RESPONSE TO REQUEST FOR ADDITIONAL INFORMATION

APR1400 Design Certification

RAI No.: 15-7896
SRP Section: 12.02 – Radiation Sources
Application Section: 12.2
Date of RAI Issued: 05/22/2015

Question No. 12.02-4

Figure 1. Flow Diagram of Condensate Polishing System

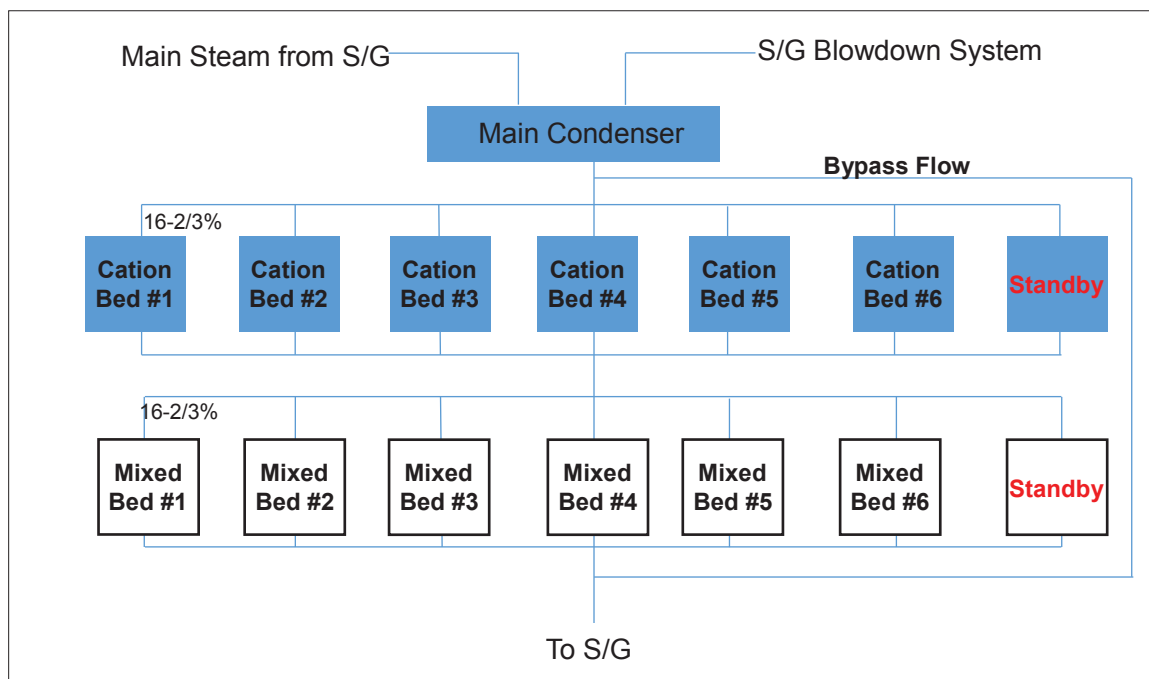
2. For the condensate polishing system, FSAR Section 12.2.1.1.5.3 indicates that, "It is assumed that 65 percent of the condensate flows through the CPS and that one out of six CPS demineralizers is used to process the condensate during normal operation." However, FSAR Section 10.4.6.2.1 indicates that there are seven pairs of cation-bed ion exchanger vessels and mixed-bed ion exchanger vessels in the condensate polishing system (CPS) and that the CPS processes approximately 16 to 100 percent of the condensate flow during normal plant operation.

- b. Please indicate if during normal operation condensate is expected to flow through only one pair of demineralizers at a time or if multiple pairs of demineralizers will be used at the same time.

- c. Please justify why 65 percent of the condensate was assumed to flow through a demineralizer when FSAR Section 10.4.6.2.1 indicates that the CPS can process as much as 100 percent of the condensate flow during normal plant operations.

- b. As illustrated in Figure 1 below, the CPS processes 16-2/3 to 100 percent of the condensate during normal plant operation depending on the three operating modes: 1) full flow mode, 2) partial flow mode, and 3) bypass mode. When the system is in operation in the full flow mode, 100 percent of condensate flows through six pairs of CBVs and MBVs. During partial flow operation, 16-2/3 to 83-1/3 percent of condensate flows through one to five pairs of CBVs and MBVs. On the other hand, during bypass mode where the condensate purification is not required, no condensate flow passes through the CPS.

- c. During normal operation, the condensate in the condenser contains 65 percent of the total main steam flow rate, and the blowdown flow rate from SGBDS. This flow is processed through one to six pairs of CPS demineralizers depending on the operating modes. DCD Subsection 12.1.1.1.5.3 states that 65 percent of the condensate is

processed through the CPS. This is not accurate and should say 65 percent of main steam flow is processed through the CPS. Therefore, this subsection will be revised to be consistent with Subsection 10.4.6.2 as indicated in the Attachment.
